SAM DA1 Family Silicon Errata and Data Sheet Clarification

The following typographic corrections and clarifications are to be noted for the latest revision of the device Data Sheet (40001895A). The corrected information is shown in **BOLD** type.

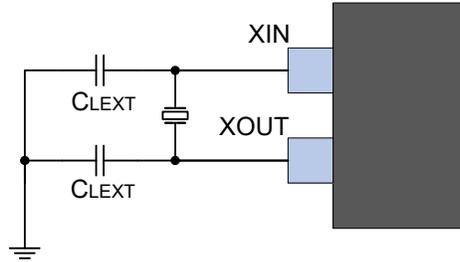
The load capacitor values shown in figure 41-6 and table 41-5 should not be used. C_{LEXT} should be calculated from the Load Capacitance Equation listed below. The corrected information is shown in **BOLD** type.

Load Capacitance Equation

$$C_{LOAD} = ([C_{XIN} + C_{LEXT}] * [C_{XOUT} + C_{LEXT}]) / ([C_{XIN} + C_{LEXT} + C_{LEXT} + C_{XOUT}] + C_{STRAY})$$
